**CONSOLIDATED EDISON COMPANY OF NEW YORK, INC.
INDIAN POINT NUCLEAR GENERATING UNIT NO. 2**

**FIRST SUPPLEMENT TO:
PRELIMINARY SAFETY ANALYSIS REPORT**

INTRODUCTION

This exhibit contains answers to the questions raised by the AEC Regulatory Staff in its letter to Applicant dated February 28, 1966.

FIGURE 3-1

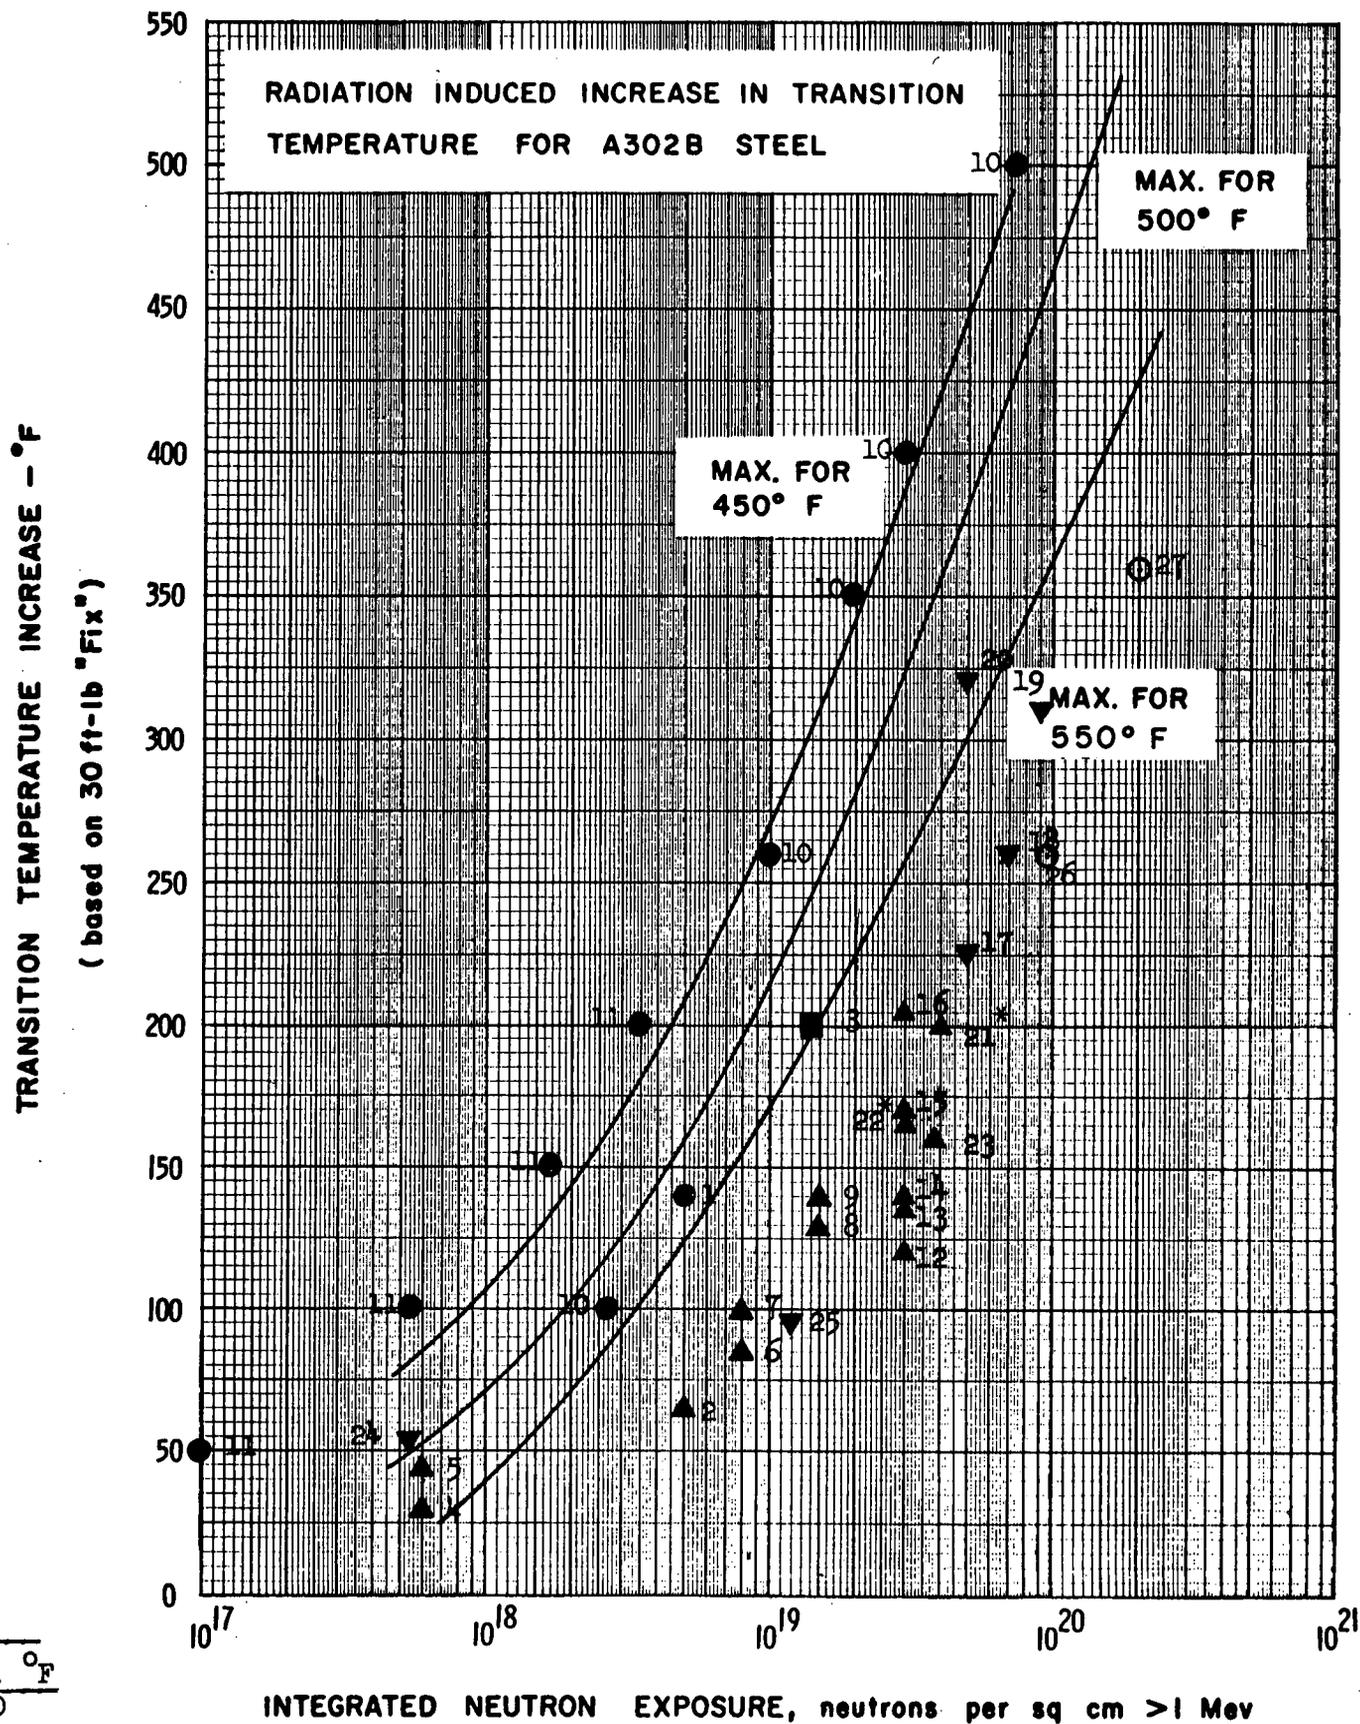
- c. Please give details on method of prediction of NDT shift with fast neutron dose and quantitatively describe uncertainties therein, including considerations of weld regions and heat affected zones.

The reference design curves used for the prediction of NDT shift with fast neutron exposure are presented by Figure 3-1. For the Indian Point Unit #2 reactor vessel, the 550°F maximum curve is being used because the vessel is exposed to inlet coolant of about 543°F. The radiation effects data at 550°F show that less NDTT shift is expected than the design value predicted by the 550°F curve.

Using a best fit curve for the 550°F data points a margin of about $2.0 \times 10^{19} \text{ n/cm}^2$ above the assumed design point of $.85 \times 10^{19} \text{ n/cm}^2$ would be obtained with a corresponding NDT shift of 160°F at the inner surface of the vessel.

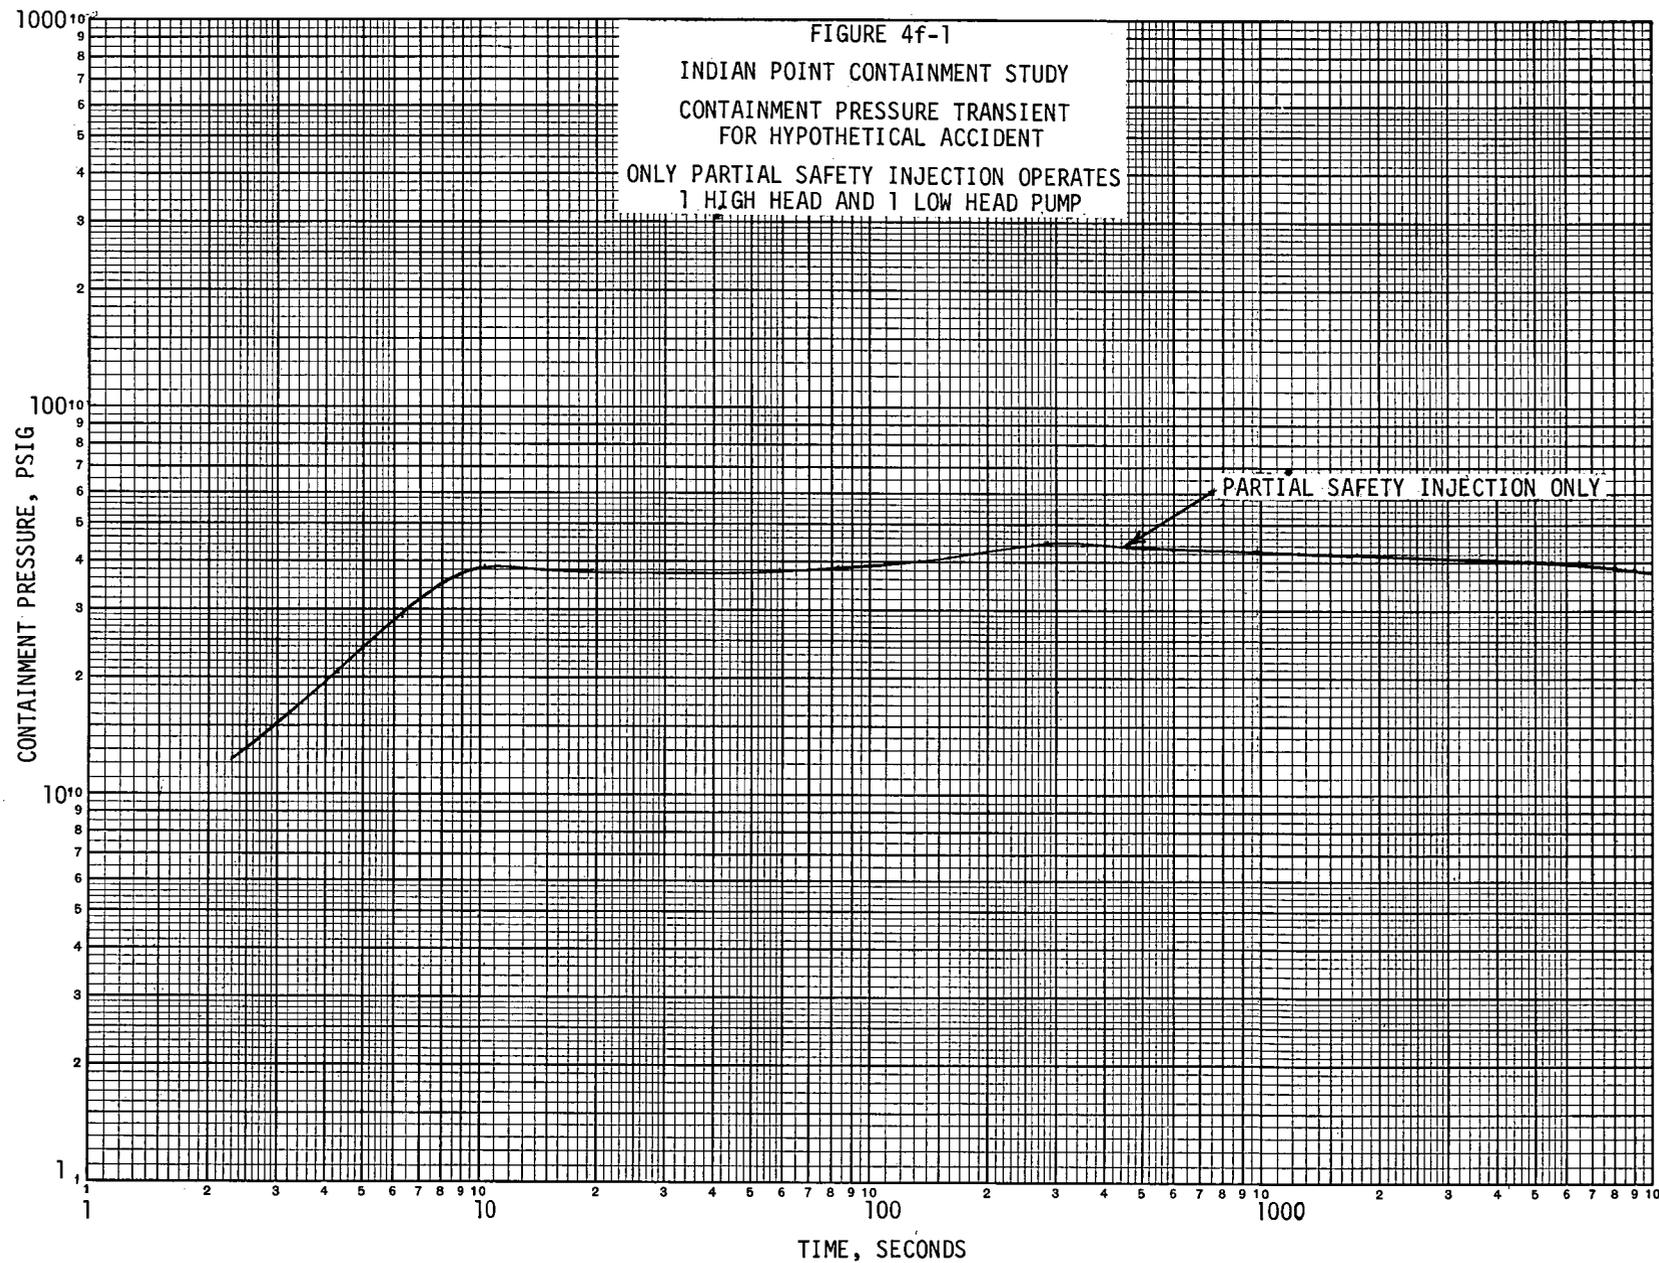
- f. Provide the containment pressure transient curves following the MCA for the cases in which the only engineered safeguards assumed to function are: (1) one high head and one low head safety injection pump, and (2) one containment spray pump, and (3) four containment air recirculation coolers.

The pressure transient for this case is shown on Figure 4f-1. During the blowdown of the reactor coolant system, the containment pressure rises to 39.2 psig at 10 seconds. Following blowdown, the containment pressure slowly rises to a peak of 44.8 psig at 280 seconds as part of the safety injection water is boiled away during the core cooldown transient. Once the core is cooled and covered with water, the safety injection water continues to remove the core decay heat, but is not heated sufficiently to flash when it spills into the containment through the break. The containment structure continues to condense steam, and the pressure slowly falls. At 4150 seconds, the refueling water storage tank is emptied. Water is then drawn from the mixture of reactor coolant and spilled safety injection water in the containment sump. This recirculation water is cooled in a single recirculation heat exchanger, then pumped back to the core at the 3000 gpm capacity of the residual heat removal pump via the core deluge and safety injection lines. The recirculation heat removal is less than the core decay heat for much of the transient shown on Figure 4f-1, but additional steam is not formed because the containment sump water is still subcooled. Structural heat sinks and the recirculation through the residual heat exchanger continue to reduce containment pressure until the analysis is stopped at about 3 hours.

FIGURE 5-2

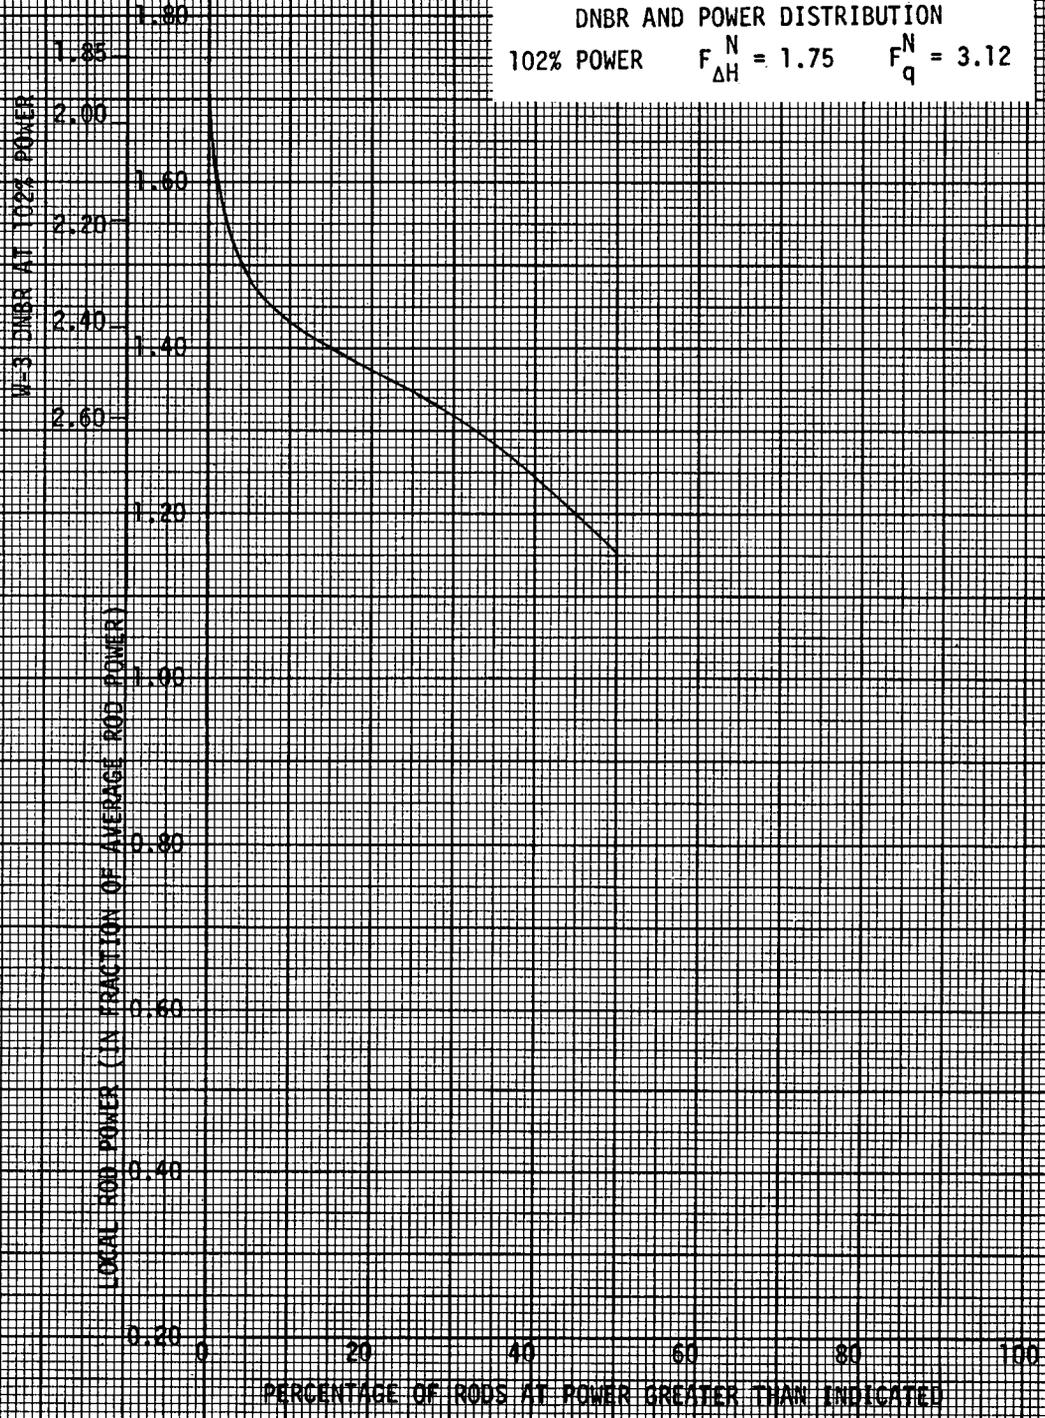
- c. For condition (a-2), provide the total number of fuel rods that are within 90% of the design peak power level and the corresponding DNB ratios (include the effects of instrument errors).

As demonstrated in Figure 5-2, there are approximately 800 fuel rods out of a total of 39,372 fuel rods that are within 90% of the peak power level. DNB ratios are shown in Figure 5-2. The following conditions were used:
